CITY OF DELAND
REGULAR MEETING OF THE PLANNING BOARD
NOVEMBER 16, 2022 AT 5:00 PM
CITY HALL, COMMISSION CHAMBERS
120 SOUTH FLORIDA AVENUE

1. Applicant Name Sean Fortier
Project Number PSB22-138 – Preliminary Plat for Trinity Gardens
Project Location 183.93 acres located at the NE corner of S. Blue Lake Ave. and E. Beresford Ave.
Project Deion Development of 543 single-family homes
2. Applicant Name: George Dennison
Project Number: Z22-161 – Rezoning for Residential
Project Location: 216 S. Florida Ave.
Project Description: Rezone 23,247 sq. ft. from C-2 (General Commercial) to C-2A (Downtown Commercial)
3. Applicant Name: Mark Watts
Project Number: AN22-168 – Annexation for Longbranch DeLand
Project Location: North side of Greens Dairy Rd., east of N. Spring Garden Ave.
Project Description: Annex 10 acres
4. Applicant Name: Mark Watts
Project Number: SMLU22-169 – Comprehensive Plan Amendment

At the October 20, 2022 Technical Review Committee meeting, members recommended the Preliminary Plat be forwarded on to the Planning Board, subject to the addressing of Staff comments. The following Staff comments remain:

City of DeLand
PLANNING BOARD
PSB22-138
NOVEMBER 16, 2022

TREE REMOVAL &
PROTECTION PLAN

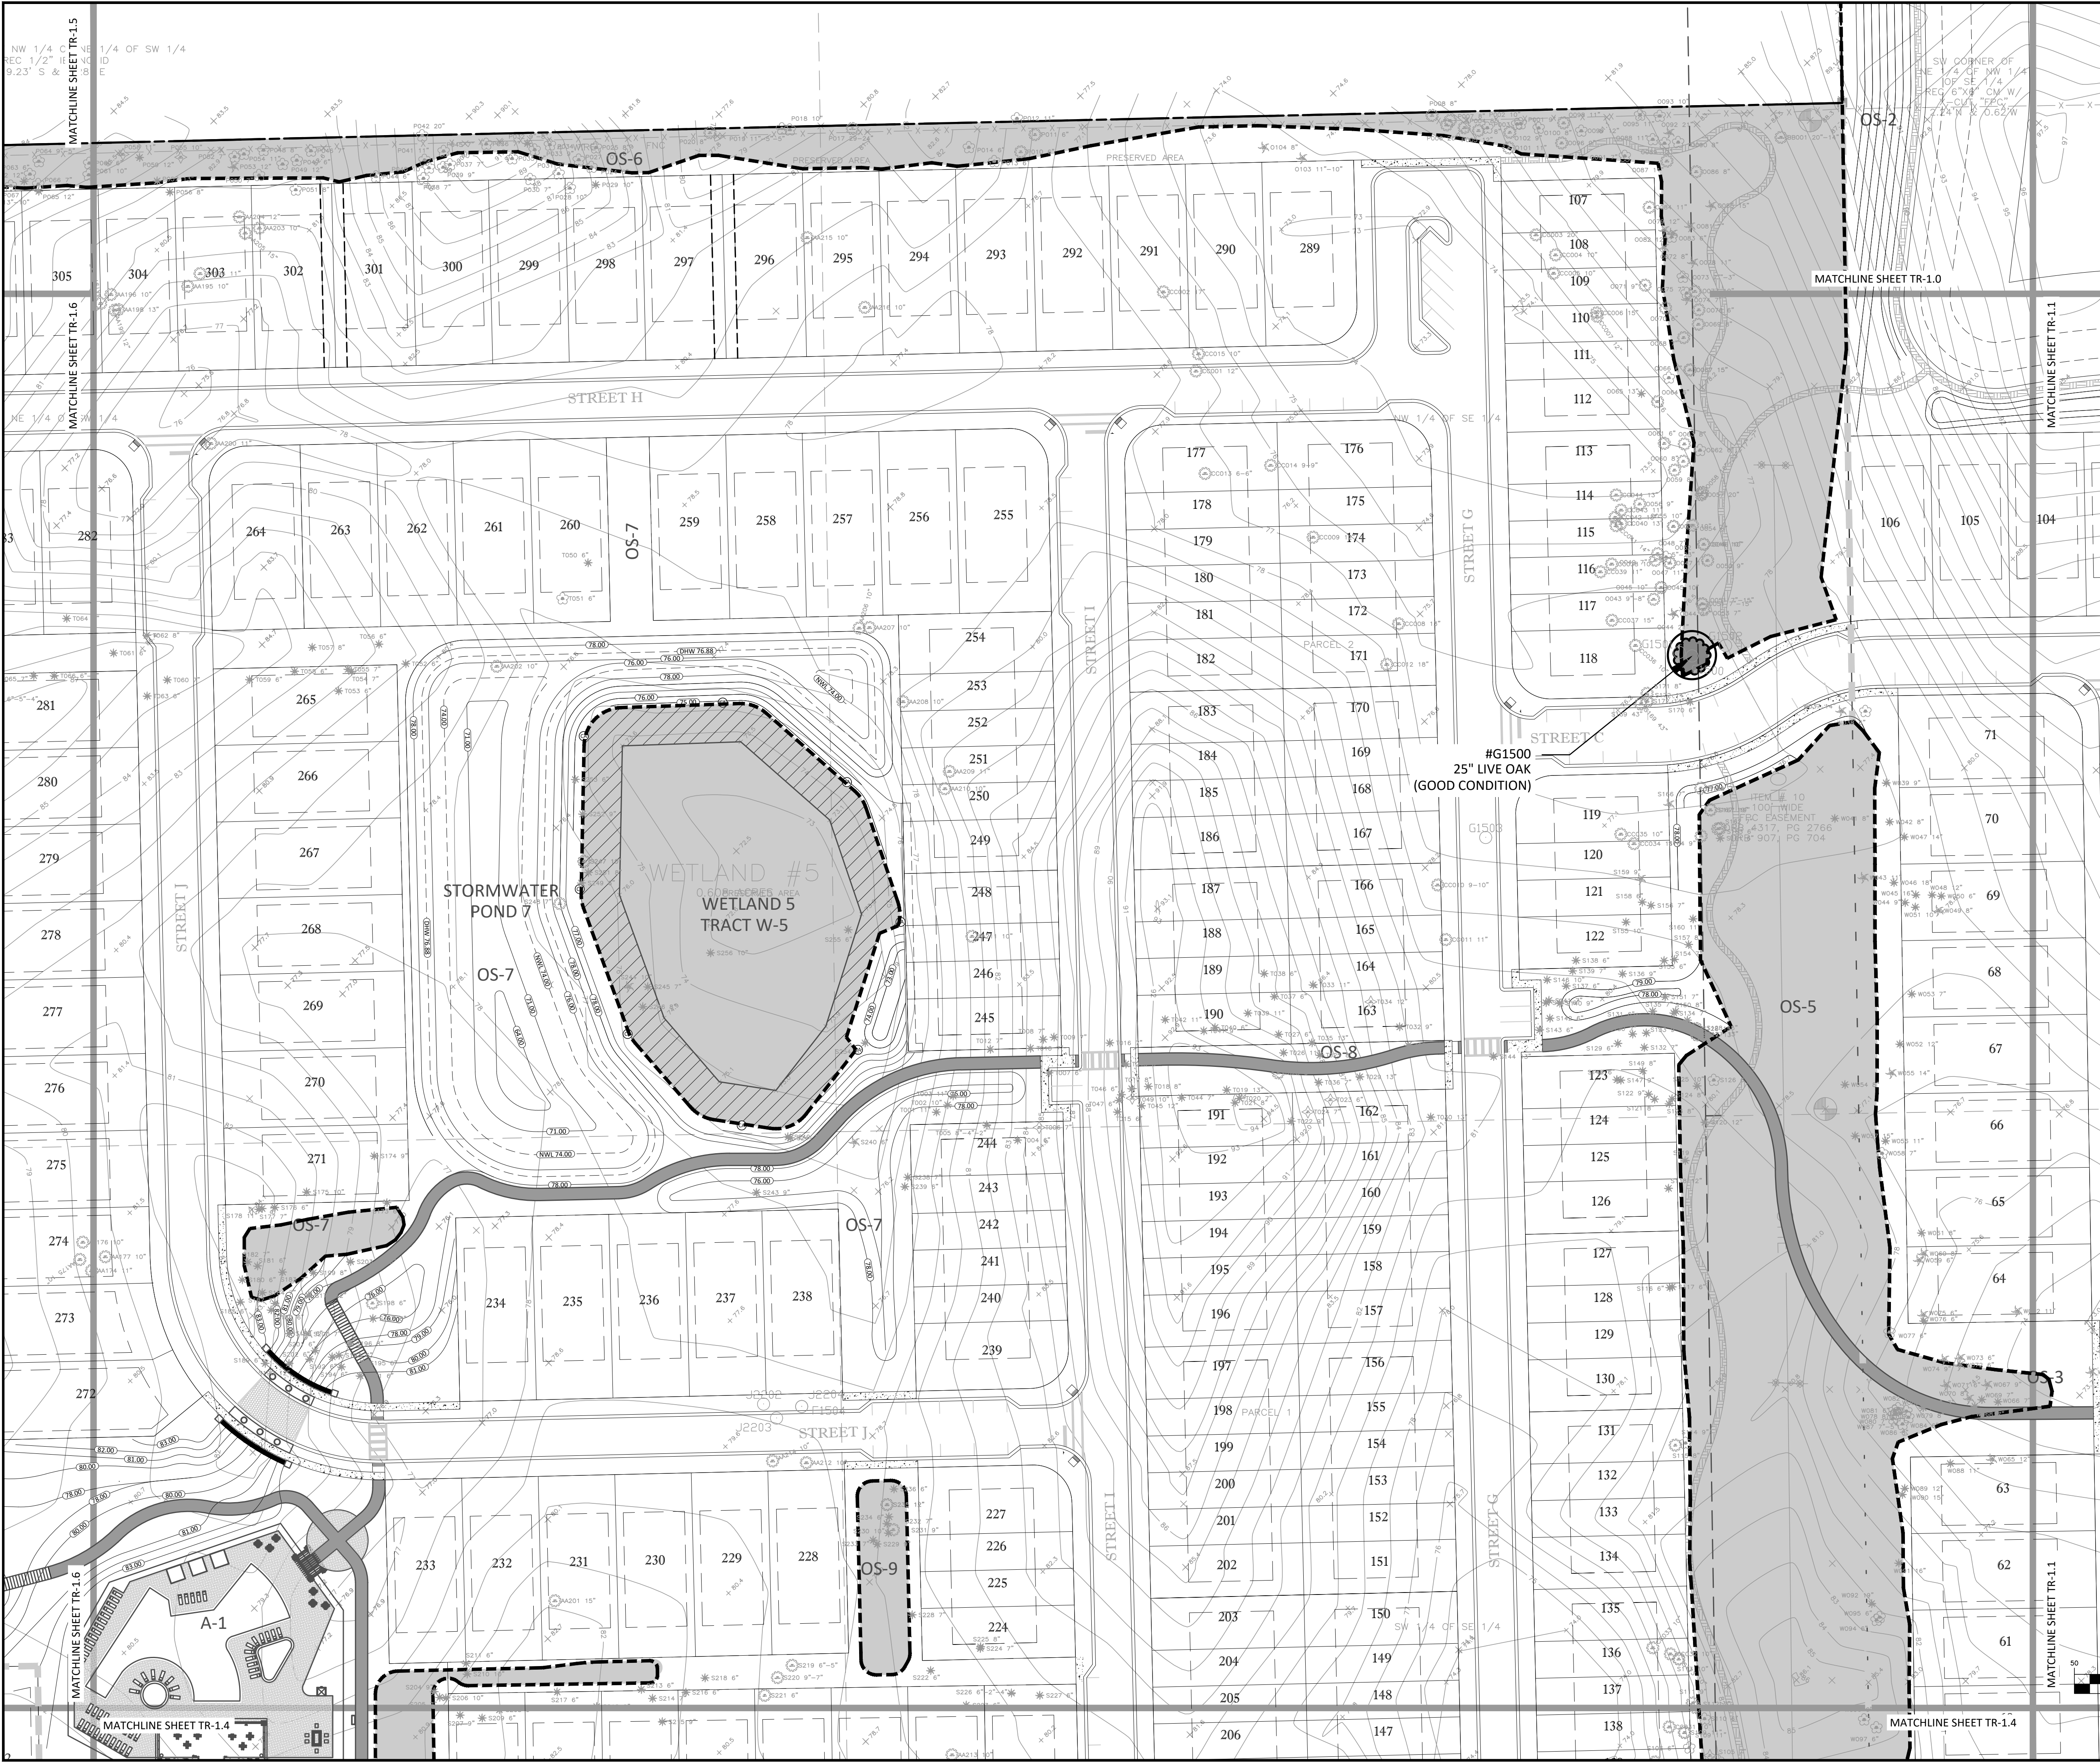
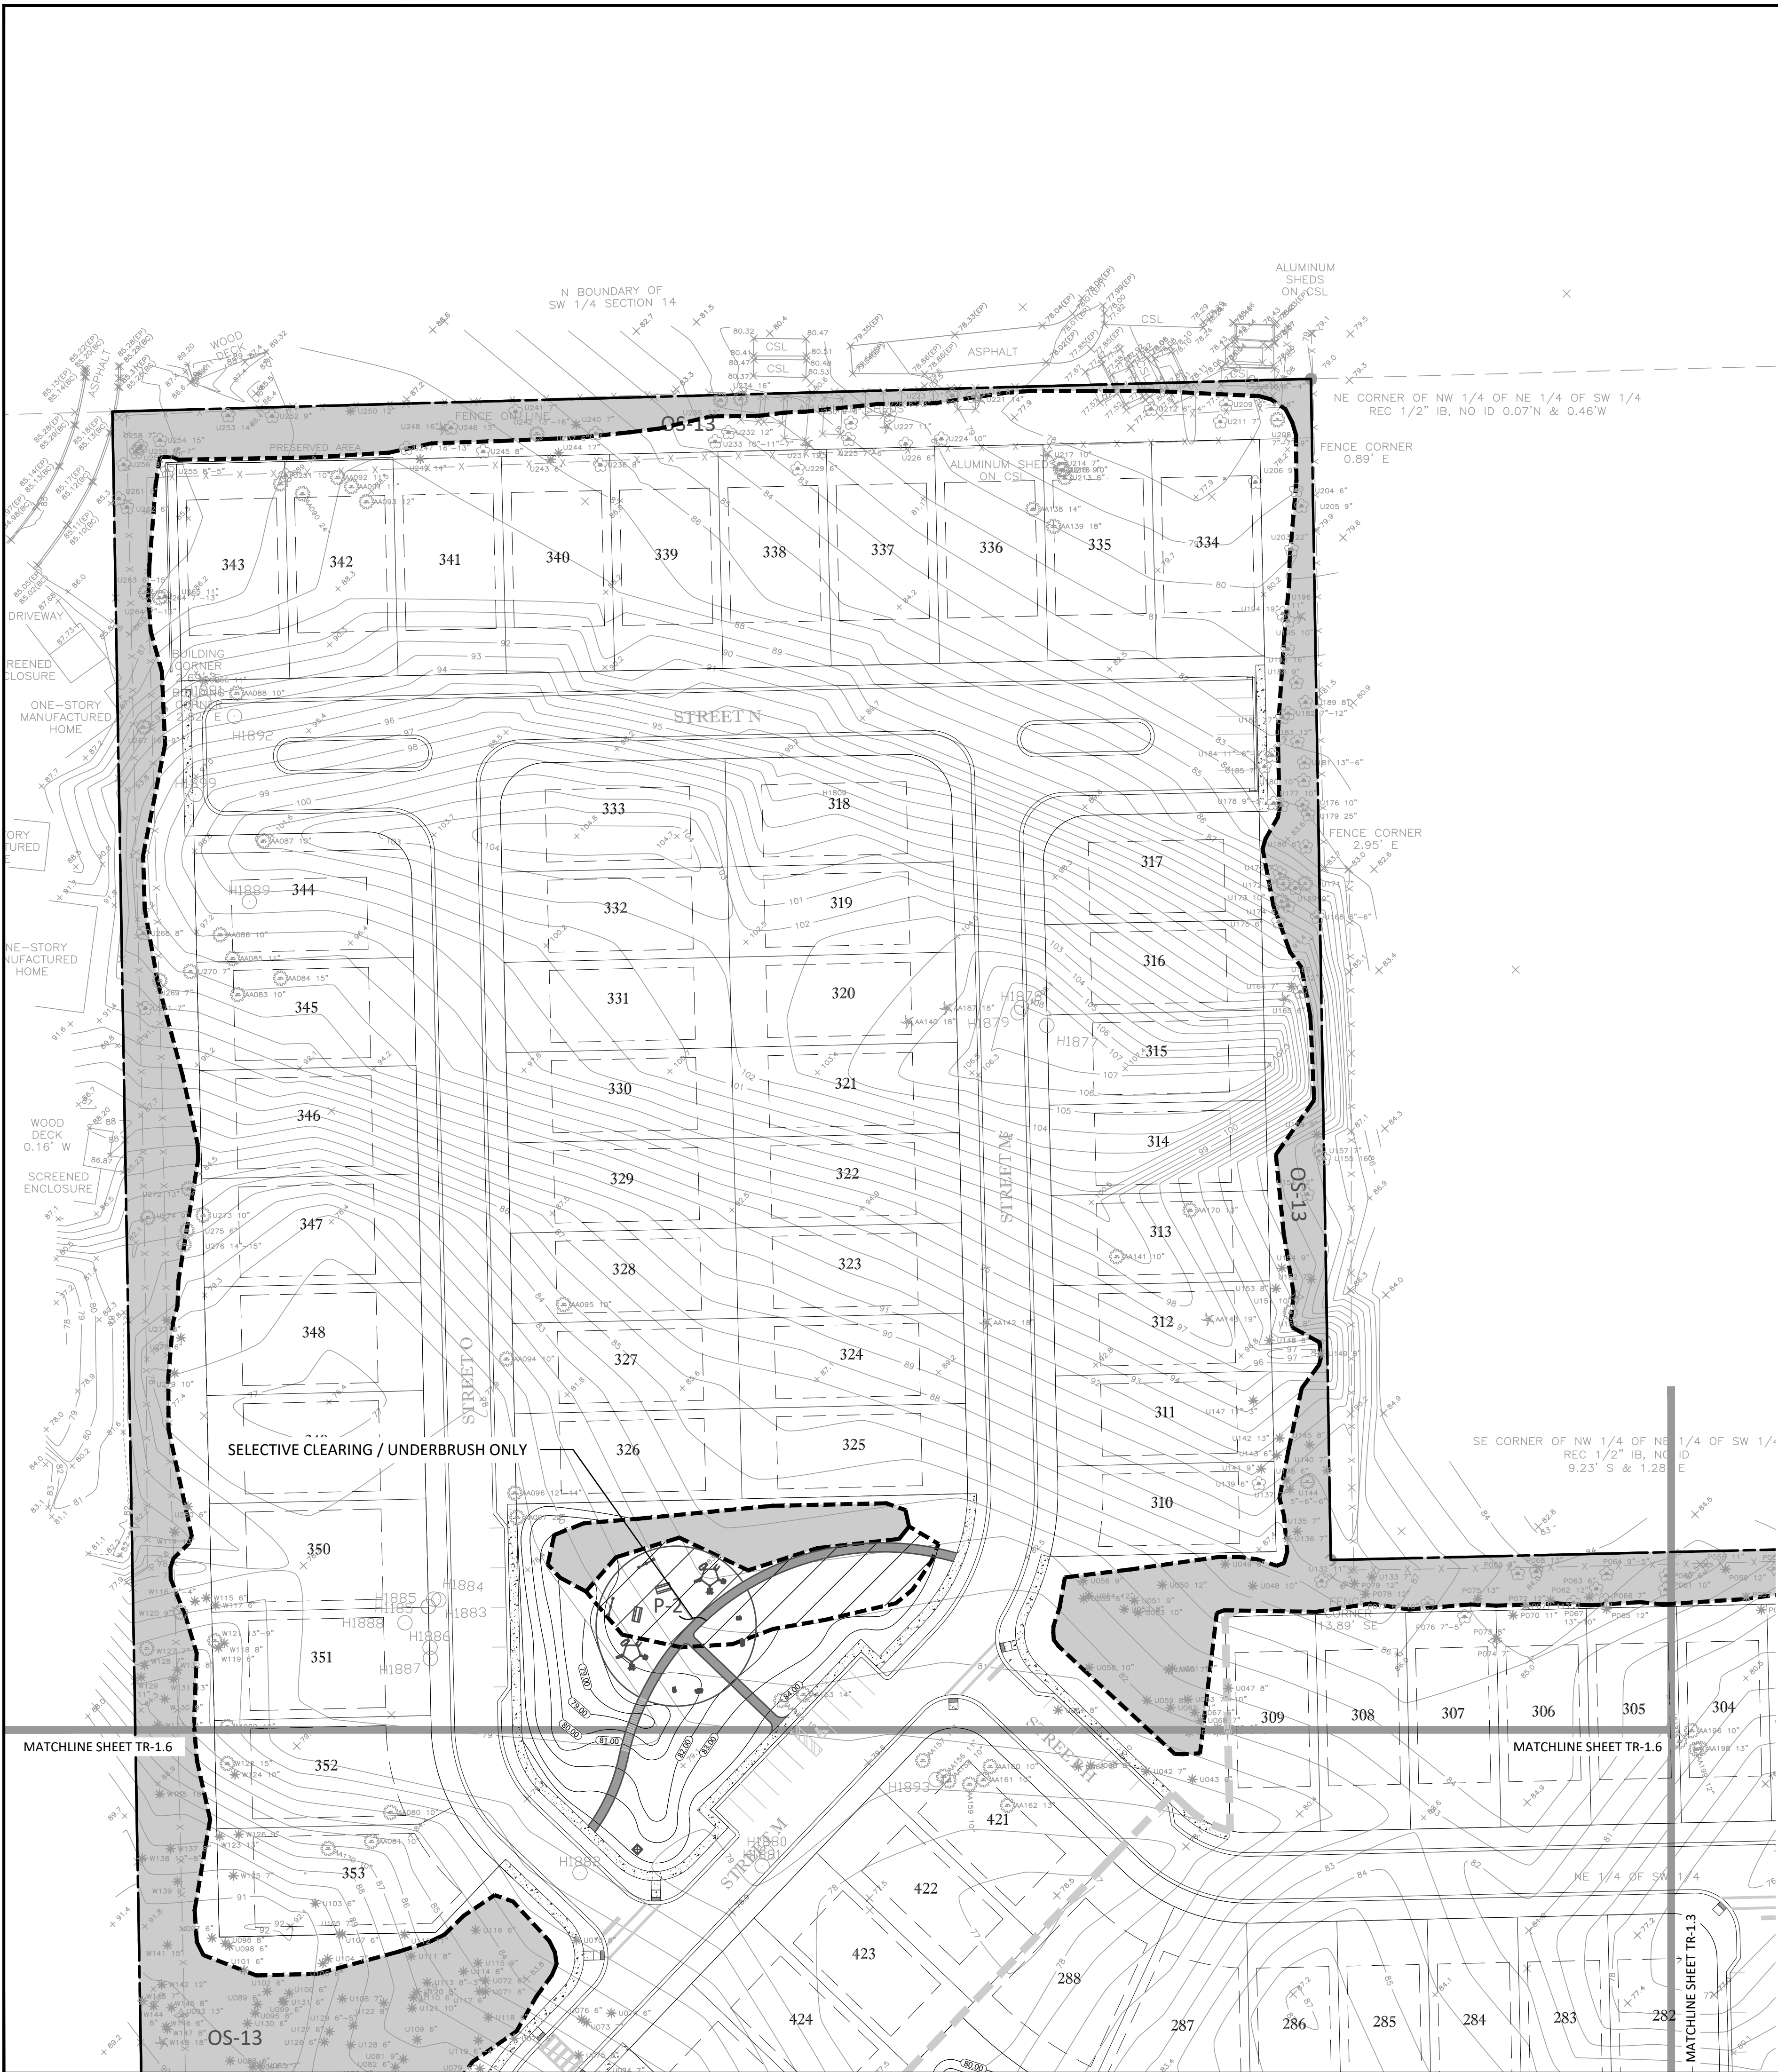
- 3) Additional comments will be provided when required data is presented. Are site trees and buffer trees included in the Code Plant Schedule?
- 4) Three inch caliper is the minimum size for replacement species.

- 5) Insufficient tree data has been provided. I have reviewed what has been presented; however, there will be many additional comments when sufficient tree data is provided. No data on trees removed or remaining has been included, so I cannot comment on tree replacement at this time.

- 6) Historic Trees: There are several historic trees in the project area. Each historic tree and the limits of its dripline need to be clearly identified on the site plans. Historic Trees: Any historic tree that is proposed for removal will require a review by this office, the City Tree Advisory Committee and approval by City Commission. The developer must demonstrate that the tree is a hazard or that it is not economically or practically feasible to develop the parcel without removing the historic tree. Historic Trees: There are several historic trees in the project area. Each historic tree and the limits of its dripline need to be clearly identified on the site plans.

- 8) Provide a spreadsheet of trees removed and remaining.
- 9) Please provide map of Sections 1 to 9.
- 10) Based on your sample areas, please provide an estimate of inches DBH lost for this project area as a result of this proposed project. I cannot determine replacement required without this information.

- 11) Add tree legend to this plan.
- 12) Add table with Lot Tree Species and Specifications
- 13) If your project area is 183.93 acres, you will need to provide 19,229" DBH to meet minimum coverage requirements.

- 14) Your table currently shows 843 trees provided. Assuming these trees are 4" DBH as shown on the plan, you will be providing 3,372" DBH of lot trees. This number will change based on revisions needed in the table.

- 16) Minimum Tree Coverage is determined with inches DBH not number of trees. Please provide spreadsheet showing trees remaining on site.

- 17) You are clearing large portions of a forested site. Your tree replacement required is NOT 0" DBH. Based on your survey, you will need to provide an estimate of inches removed of protected trees and provide 1/3 diameter replacement for these trees. Your survey should include all specimen and historic trees. You will need to provide 1/2 diameter replacement of all specimen trees and 100% diameter replacement of any historic trees removed once their removal has been reviewed by the Tree Advisory Committee and approved by the City Commission. The minimum size for replacement of historic trees is 6" caliper. None of the trees provided meet this requirement.

- 18) Based on your landscape plan, you may be missing two historic trees on this page. what happened to the 29" DBH and 36" DBH Live Oaks shown on the landscape plan (Sheet L101)?

- 19) Remove concrete walk from the area under the three historic trees that are not shown on site (but should be).
- 20) You have shown a playground within the impact area of three historic trees. How will this be constructed to avoid root impacts?
